## **Access Compliance Report Public Rights-of-Way** (Curb Ramps)

Intersection ID: 12828 Main Street: W MOREHEAD ST **Cross Street: S CHURCH ST** Location: SW **Overall Compliance: No** ADA ID: 23E2B643AA71 Ramp Type: PerpDiag Initial Pass/Fail: Fail **Severity Score:** 22.5

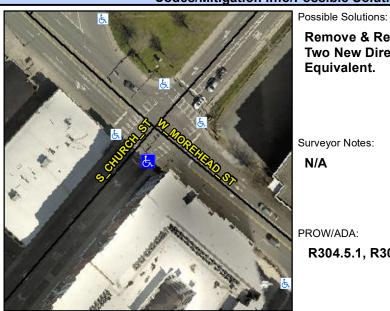
**Remove & Replace Curb Ramp With Two New Directional Ramps or** Equivalent.

R304.5.1, R304.2.2
